**CITY OF ALBANY
PLANNING COMMISSION
City Council Chambers, 333 Broadalbin Street SW
Tuesday, November 27, 2012
5:15 p.m.**

CITY OF ALBANY
PLANNING COMMISSION
City Hall Council Chambers, 333 Broadalbin Street
Monday November 19, 2012
5:15 p.m.

TO: Albany Planning Commission
FROM: Heather Hansen, Planning Manager
DATE: November 21, 2012, for the November 27, Planning Commission Meeting
SUBJECT: South Albany Area Plan (SAAP)

FIG. 2 Prohibited

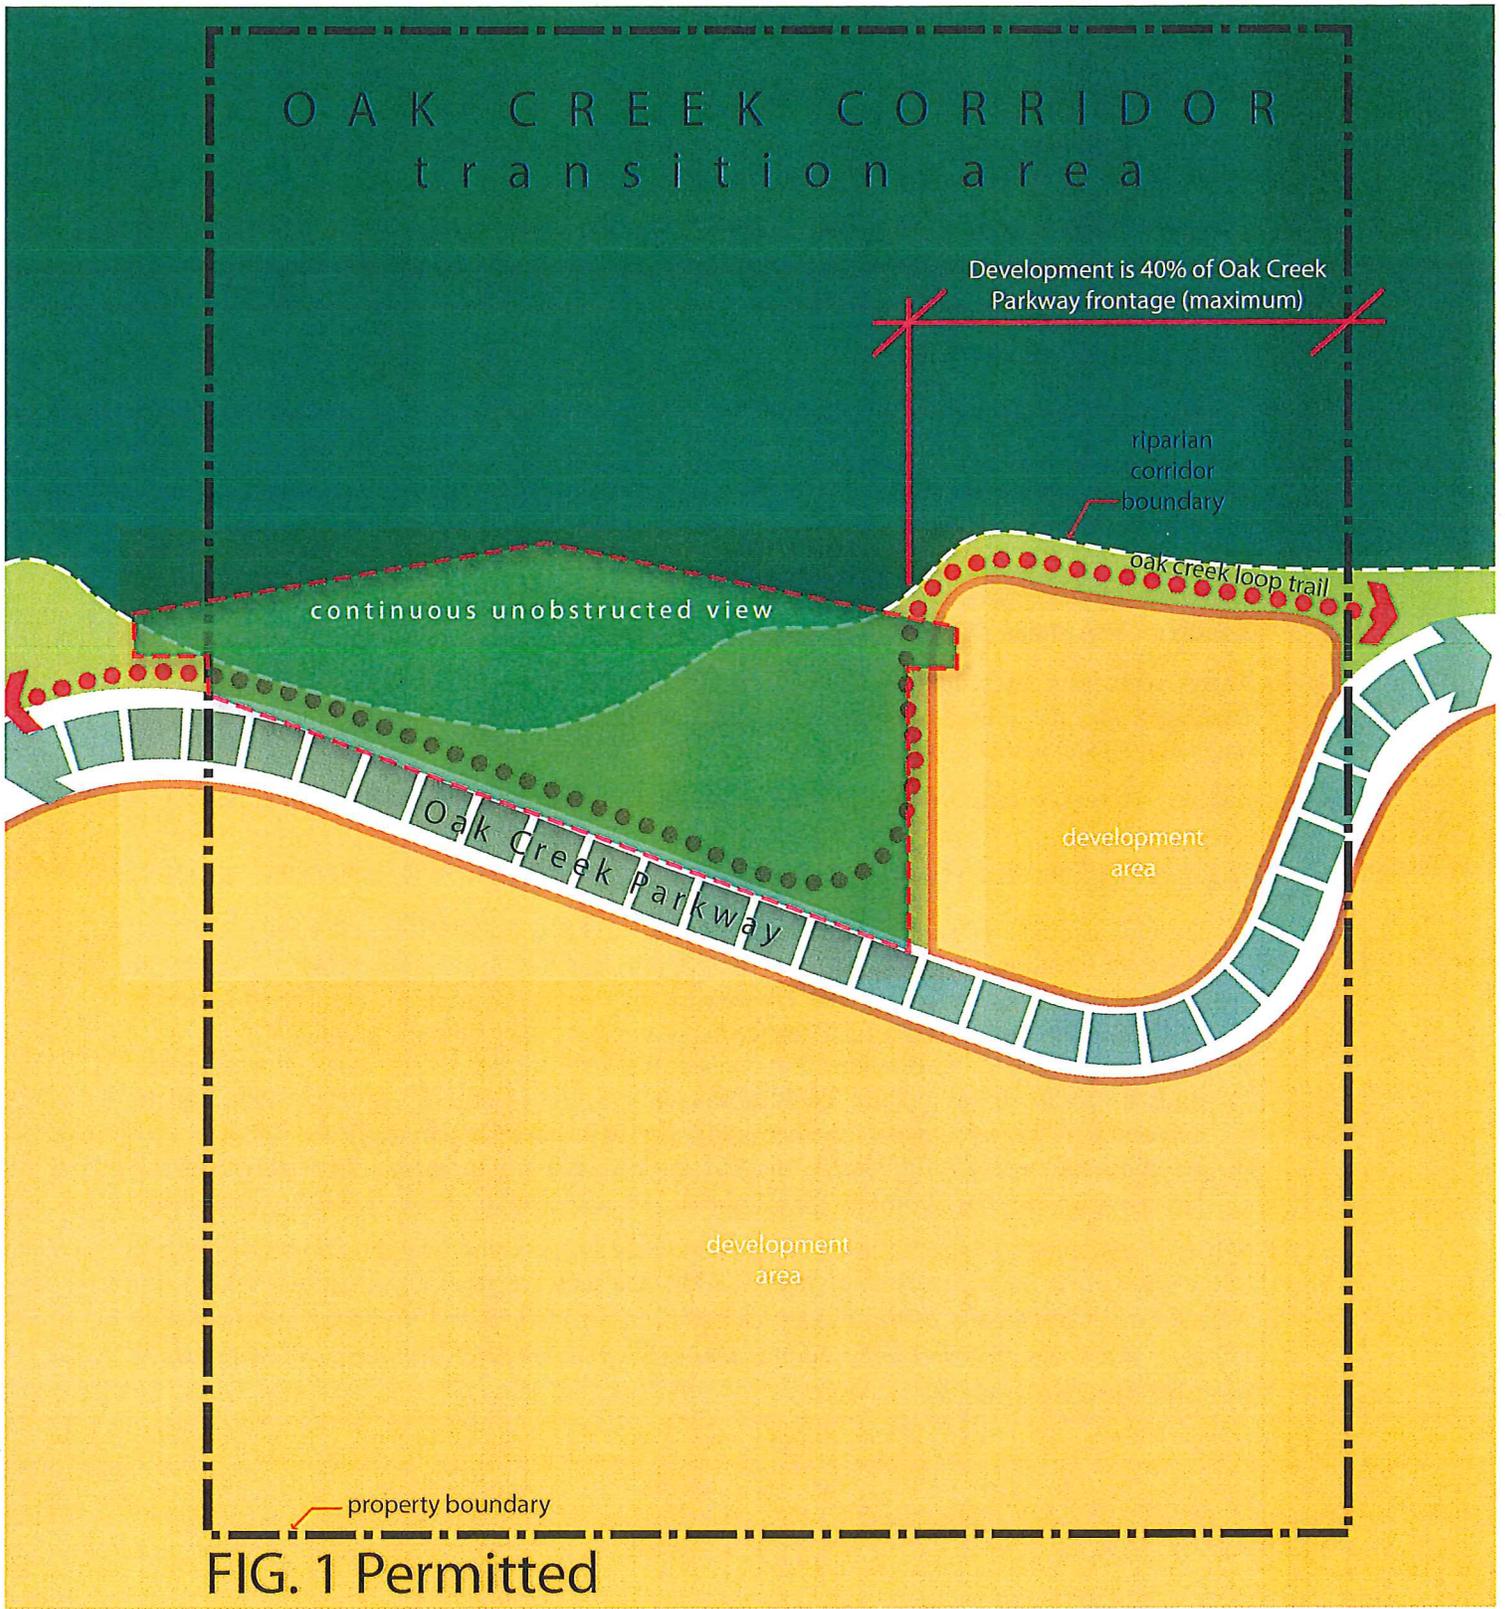
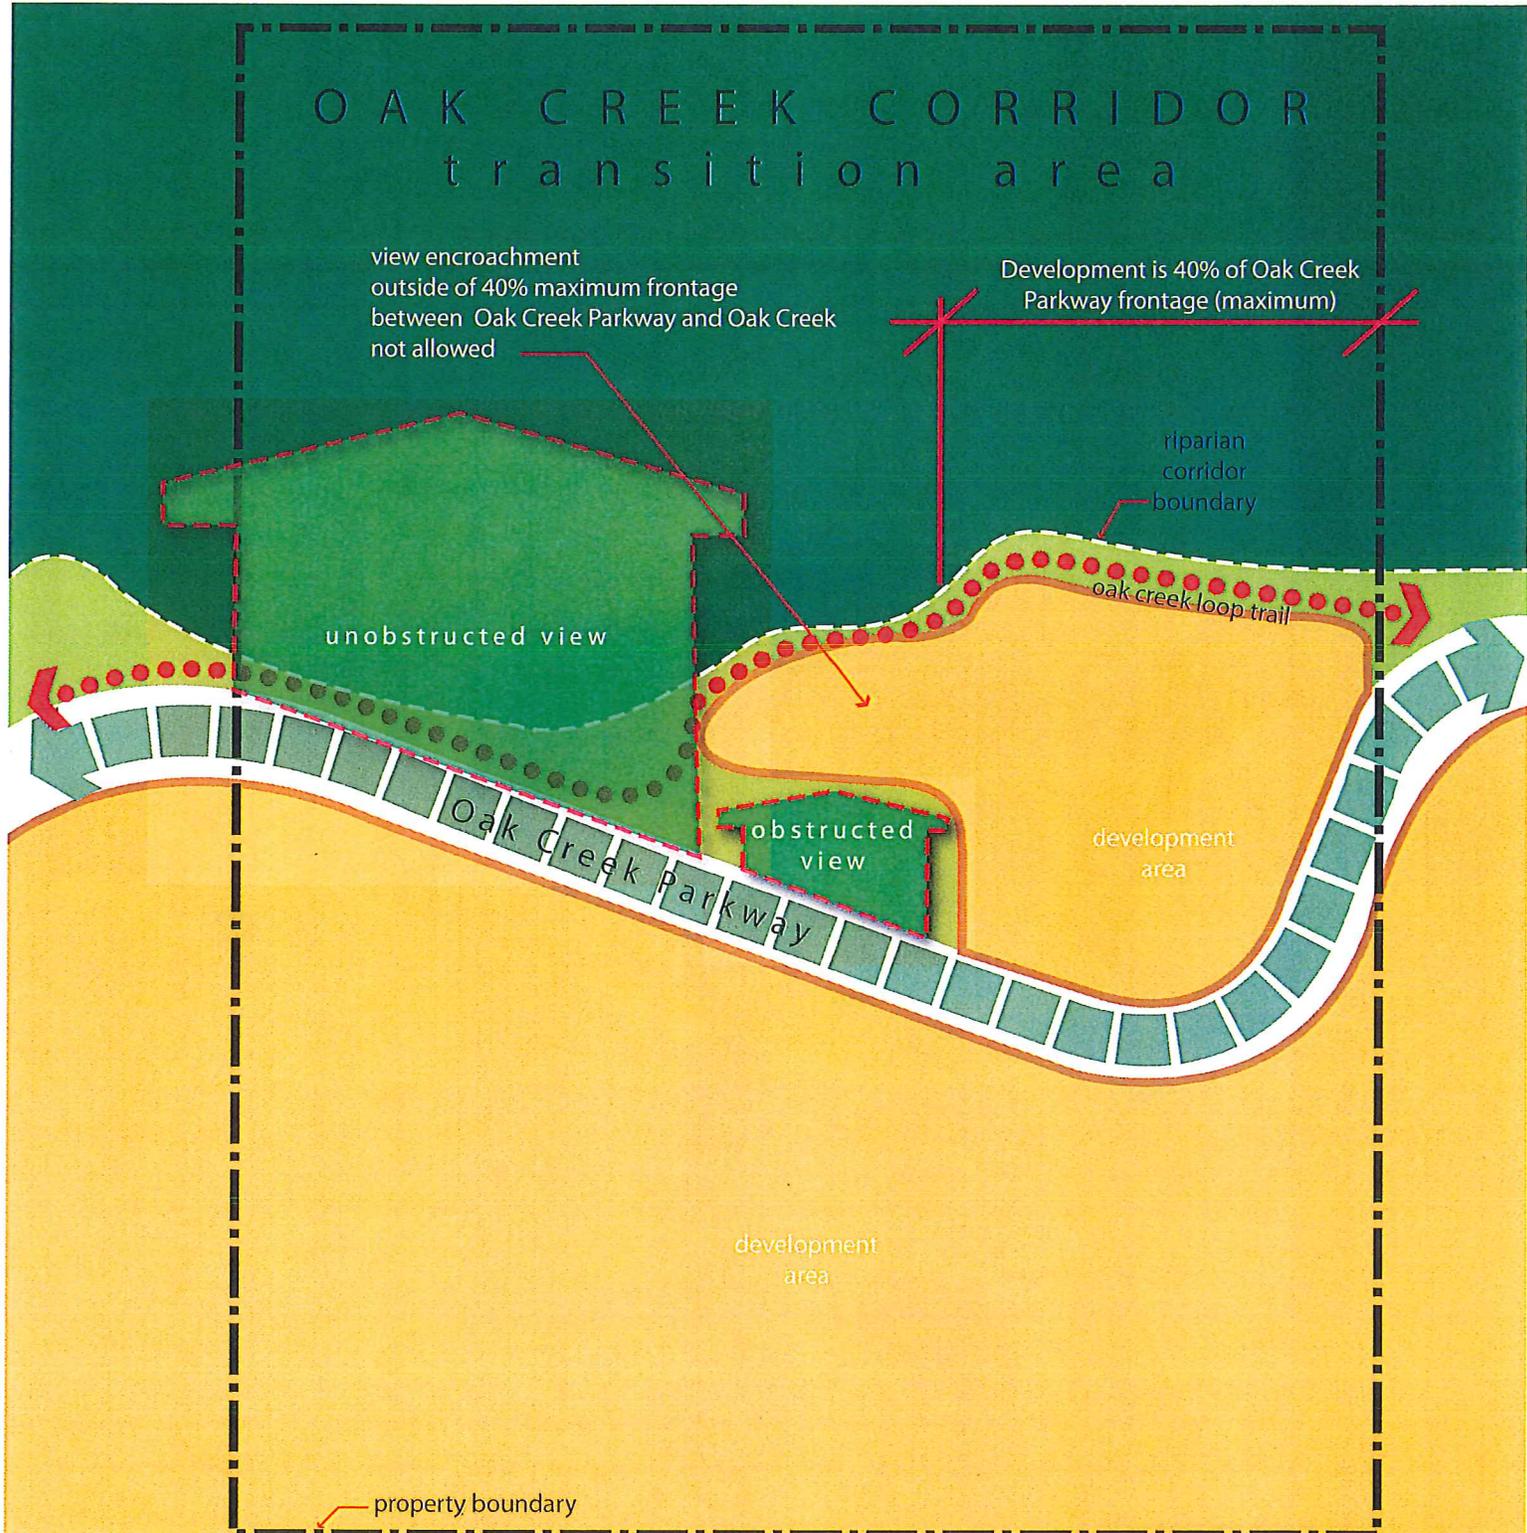
Staff response: Staff expressed concern about how there may be unintended consequences based on how it could be interpreted by other developers, therefore proposed revisions to Article 8 are presented in **Attachment A**.

- A. Status quo – include both frontage and area as proposed.
- B. Change language and diagrams to clarify intent of "40% of frontage" as described in **Attachment A**.

Staff response: Original proposals were in the 20-30% range. The number was increased to 40% after discussions with property owners. If development in the OCTA is designed as envisioned, 50% could work. And due to wetlands and other constraints, it will be difficult to reach in many cases anyway.

- A. Status quo – maintain 40%
- B. Change to 50%

- (3) Development between Oak Creek and the Oak Creek Parkway, and between 99E and Columbus Street must meet the following standards:
 - (a) The “development area” cannot exceed ~~neither 40 percent of the site’s land area within the OCTA nor~~ 40 percent of the subject site’s frontage on the north side of Oak Creek Parkway. See the illustration in Figure 1. The “development area” shall include all residential lots and development, all areas taken up by buildings, private yards, paving, streets, grading and non-native landscaping, but does not include parks, low-impact outdoor recreation, trails, paths, wetland mitigation or restoration, City construction of public infrastructure such as transportation, stormwater, sewer, and water utilities, or the private construction of public transportation and utility facilities and structures as identified in a City-adopted master plan. **The resulting undeveloped frontage along the north side of Oak Creek Parkway shall have a continuous view of the Oak Creek Corridor and associated open spaces that is not obstructed by the development area. See Figure 2.** *Staff Comment: The 40 percent maximum “development area” standard is necessary in order to maintain visual and physical access to Oak Creek from the Oak Creek Parkway.*

Figure 2. Street Framework

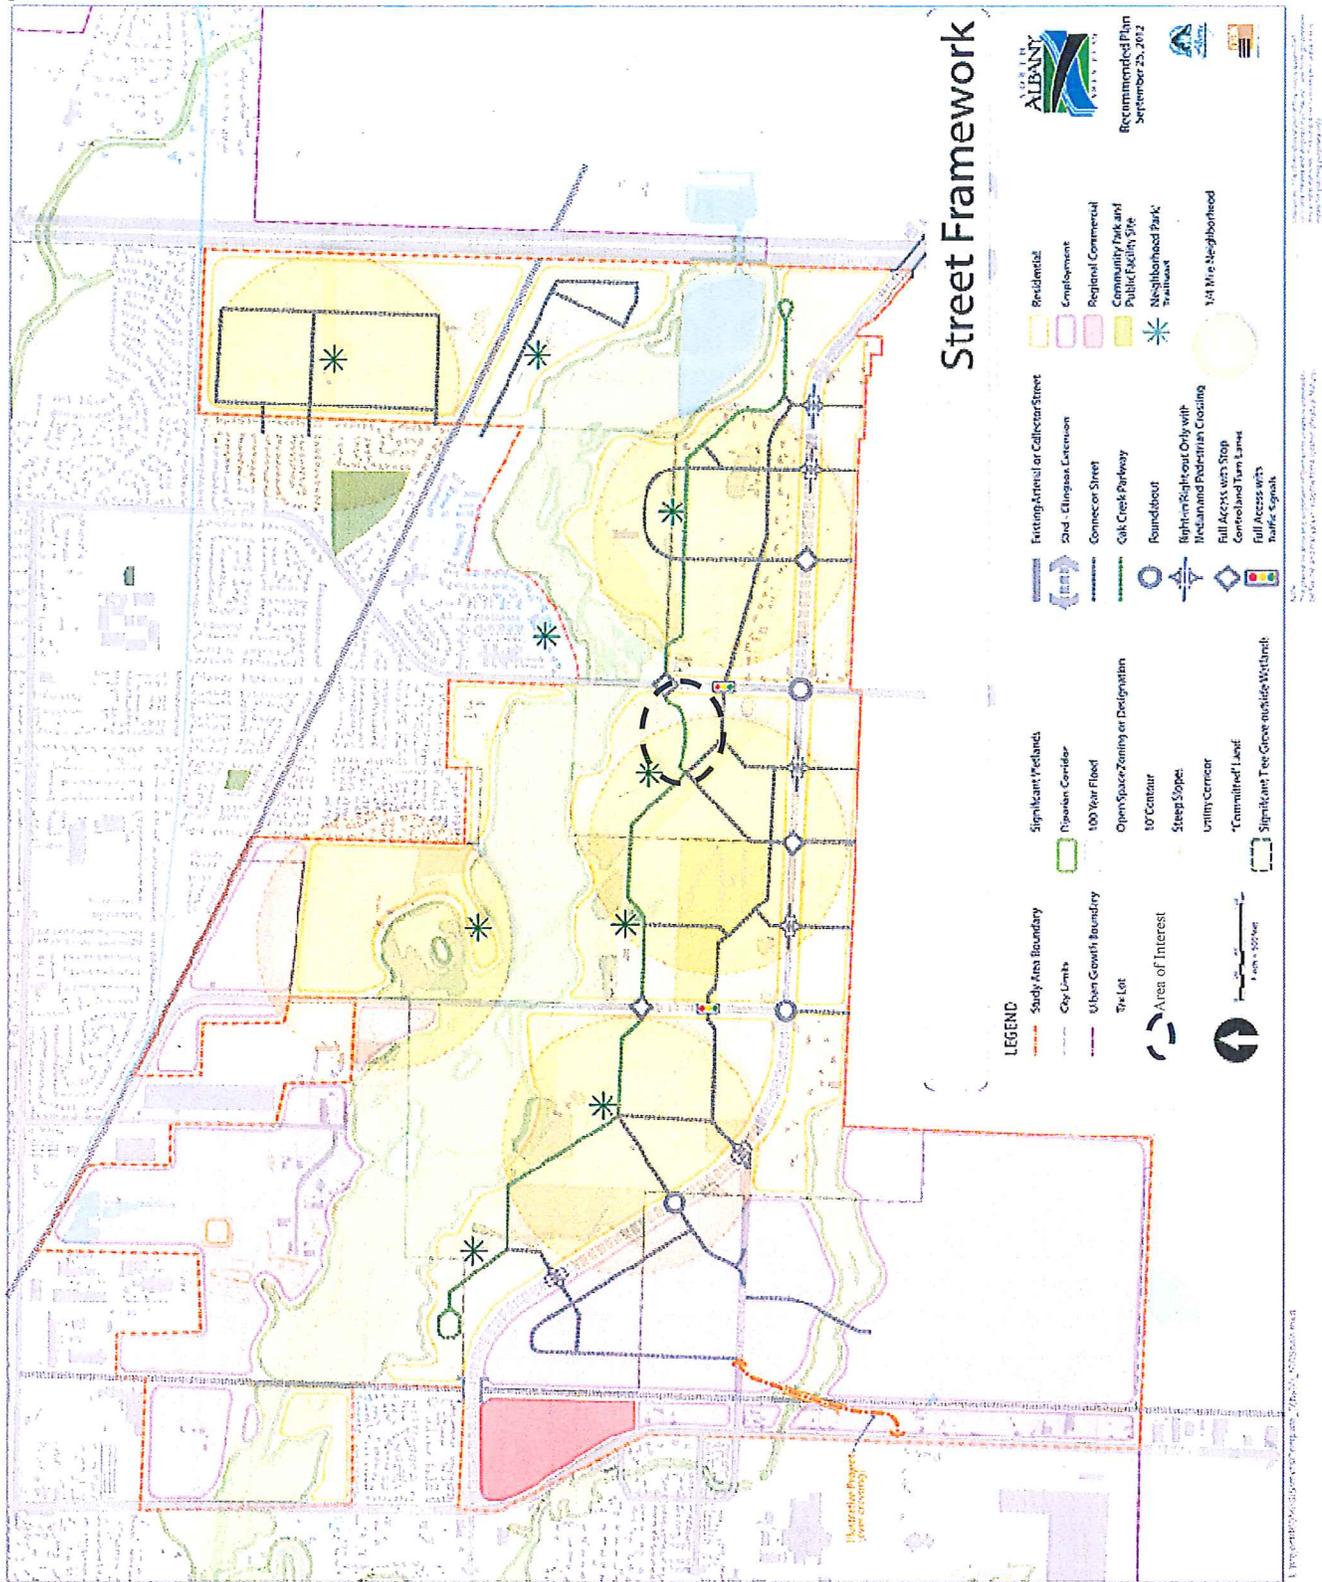
Matt Wellner proposed that an "Area of Interest" be added to the SAAP maps, and that a note be added to Article 8.

Staff response: The note shown on the Land Use Plan that was handed out at the November 19, 2012 Planning Commission meeting had a large text box at the top. It would not be workable to add this to all SAAP maps, so staff proposes alternatives.

- A. Status quo – no changes– recognizing that there are already caveats on the maps, and in the Comprehensive Plan and Development Code. For example an existing note on the street framework diagram states: *"The precise location and alignment of streets is intended to be flexible, and may vary in response to the location of natural features."*
- B. Make proposed changes to the legend on the Street Framework map in the Comprehensive Plan, and add the text to the Comprehensive Plan, and to Article 8, as suggested in **Attachment B**.

Consultant response: The intersection location at the existing driveway and Columbus is the starting point, and how the alignment continues exactly east of that is entirely up to the land owner and developer. We dipped it down to avoid the grove of trees. We went south rather than north, to create the opportunity for the tree grove to become part of the Oak Creek open space corridor, as opposed to being separated from it by the Oak Creek Parkway.

Mennonite Village response: Ron Litwiller emailed staff on November 20, 2012 (see **Attachment C**) suggesting that they have no objections to the proposal that the road be on the property line. He suspects that the drawing was done the way it was to protect the trees that are in the property line. He said he was confident that a road area could be worked out between Mennonite Village and Mr. Chapman that would achieve the City's goals.

- A. Status quo – no changes – recognizing that there are caveats on the maps and in the Comprehensive Plan that reinforce that the actual type and location of transportation facilities may vary in response to site-specific conditions. This is true for all transportation facilities other than existing intersections.
- B. Revise the diagrams to move the Oak Creek Parkway to the property line between Mennonite Village and Mr. Chapman's property.

5. Connector streets and additional local streets will be required by the City to form the full walkable block pattern for the area. The Street Framework (Figure 2) includes a network of “connector” streets. The connector streets supplement the streets designated as arterials and collectors in the TSP, providing a partial local street plan for South Albany. They are not the full network of local streets. It is recognized that site specific conditions, such as wetlands, will need to be considered in the actual development of both connectors and additional local streets. **NOTE: If wetland delineations move the Parkway much further south within the Area of Interest shown on the Street Framework, it may be too close to the extension of Seven Mile Lane west of Columbus, which would trigger re-evaluation of the two proposed street alignments.**

6. In all cases, Oak Creek Parkway shall provide visual and physical access to the undeveloped areas of the Oak Creek Transition Area.
7. Where feasible, Oak Creek Parkway, a connector street that parallels Oak Creek on the creek’s south side, should serve as the southern physical edge between developed areas and undeveloped areas in the Oak Creek Transition Area (OCTA). This two lane street will connect three neighborhood parks, two trailheads, and a potential elementary school. This is intended as recommended and guiding, not mandatory. Preferred, permitted, and prohibited development patterns adjacent to Oak Creek Parkway are illustrated in the SAAP. **NOTE: The southern boundary of the OCTA may need to deviate from the Oak Creek Parkway within the Area of Interest shown on the Street Framework (Figure 2) if the Parkway is forced south due to development constraints.**
